Table 1 Response to EPD's Request for Supplementary Information (Ref: EPD's letter dated 9th March 2011)

ANNEX A

Update to EIA Report Section 4.6.4 Trees within the Project Site (Figures 1 and 3)

Figure 4. Before damage by Typhoon Fengshen, T1 conflicted with the much bigger and more vigorous neighbour T2, resulting in crown suppression and trunk bending of T1 (photos supplied by the Trust).

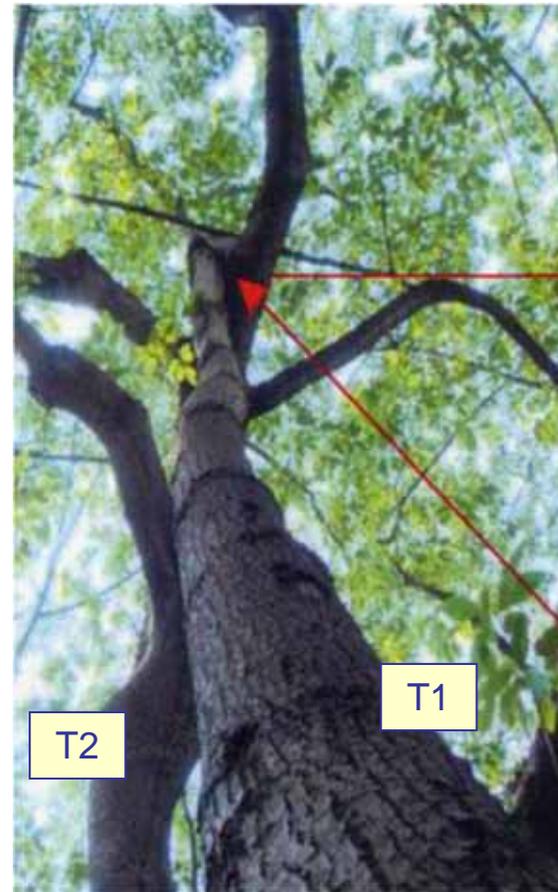
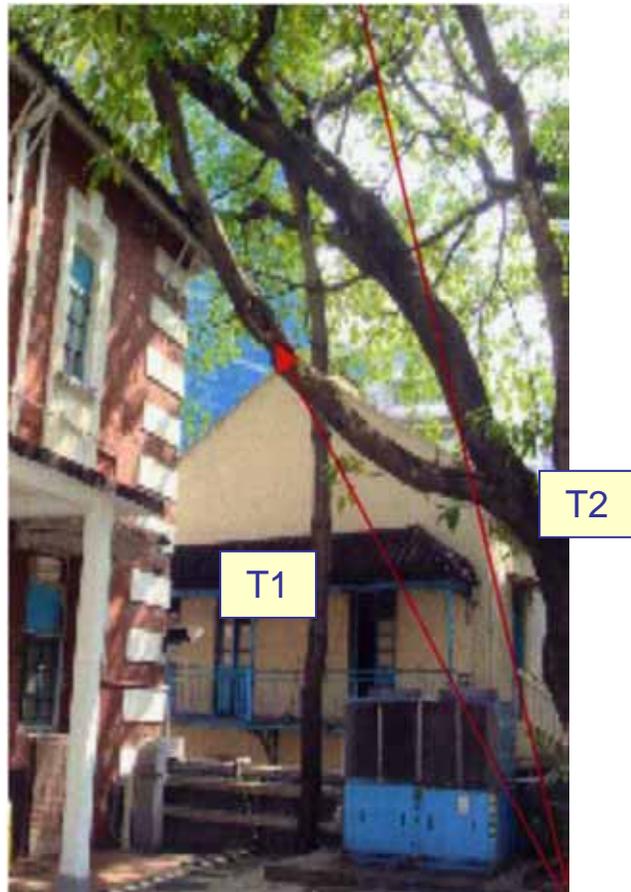
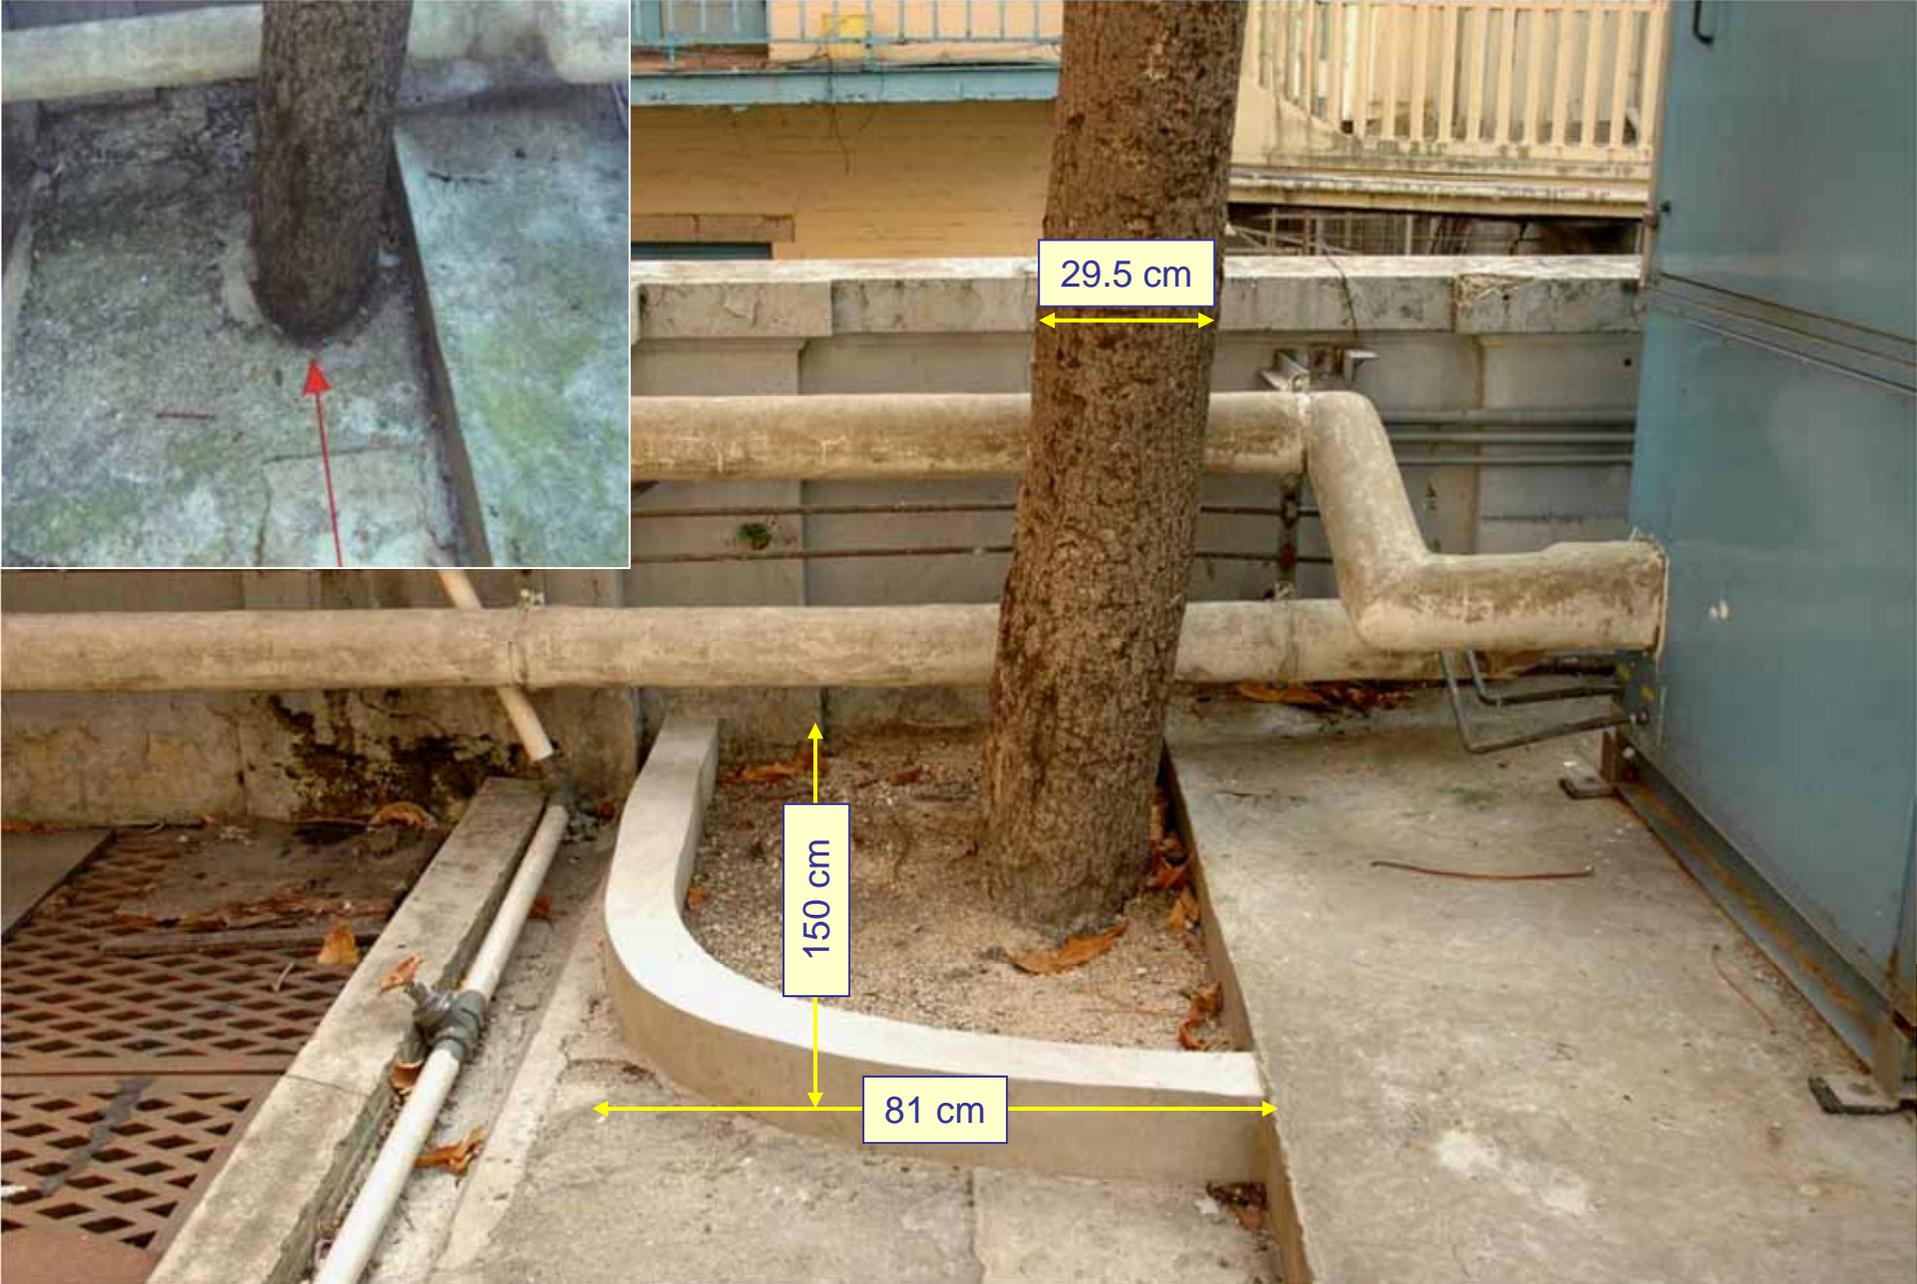
T1 – *Bombax ceiba* (Figures 4 to 11)

T1 was a medium-sized *Bombax ceiba*, around 25 years old, that measured 15 m tall and 4 m crown diameter before it was destroyed by Typhoon Fengshen on 25 June 2008. The gale force wind associated with typhoon signal number 8 snapped the trunk and completely removed its crown. Before the typhoon, the crown of T1 overlapped and intertwined with that of its notably larger neighbour T2. It is possible that T1 was brought down as collateral damage due to the collapse of the much larger and heavier T2. For a 15 m tall tree, the trunk diameter of 22 cm was on the low side and branch development was less than optimal, indicating that the tree's performance was of average or fair calibre. Only the lower segment of the trunk without any foliage was left of the tree after the typhoon though it is likely that the root system was able to remain more or less intact. Shortly after the typhoon, the top of the broken trunk was sawn to form a horizontal flat surface in an attempt to trim the breakage wound, leaving a trunk segment of 3.5 m tall. Following this, slender sprouts with new leaves developed from the edge of the wound to rebuild a tiny and unnatural crown. Measuring 1.9 m wide and with only a small amount of leaves, the reconstituted crown serves to resume a minimum amount of plant food production by photosynthesis to sustain the essential physiological functions of the emaciated tree. The wind force that caused the trunk snapping had created cracks that extend downwards from the wound.

Shortly after the typhoon attack, a small tree pit with concrete rim measuring 150 cm by 81 cm was installed for T1, where previously its critical root zone had been completely sealed by concrete paving. With the east side of the tree site bordered by a retaining wall adjacent to the access road and the north side adjacent to a building the root extension of T1 is permanently curtailed on two sides. Its roots could only spread towards to the south and west in the compacted and sealed soil lying beneath the continuous concrete paving and the root system of T1 cannot be expected to develop normally.

The installation of an air conditioner resting on a concrete plinth next to T1 would have incurred injuries to its roots. The excavation would have cut away some roots on the south side, and created wounds to permit the invasion of wood-decay fungi and other natural enemies into the root system. The weight of the concrete plinth and the machine could have overburdened the soil to dampen normal root functions and growth. In operation, the heat and air flow generated by the machine would have dehydrated the leaves and imposed additional stresses on tree growth.

T1 is a broken tree, struggling to survive by developing some unnatural water sprouts and in poor health. Although it displays some apparent signs of recovery, they indicate the last-resort physiological and morphological responses of a tree that has been pushed to the extreme. Due to the massive structural losses and associated injuries, there is no hope that the tree regaining its health and restoring its natural neat and layered pagoda tree form, which in conjunction with its large reddish bloom, constitute the *raison d'être* for planting *Bombax ceiba*. With the loss of the leader trunk that would normally dominate the tree structure from base to tip, and dim prospect of forming a replacement leader, the tree's landscape and amenity value has been permanently depleted. In addition, there is a high risk of invasion by wood-decay fungi at the existing trunk breakage which would lead to a hazardous tree situation in due course.

Considering the above assessment and taking into account arboriculture and staff and visitor safety, it is suggested T1 be removed.
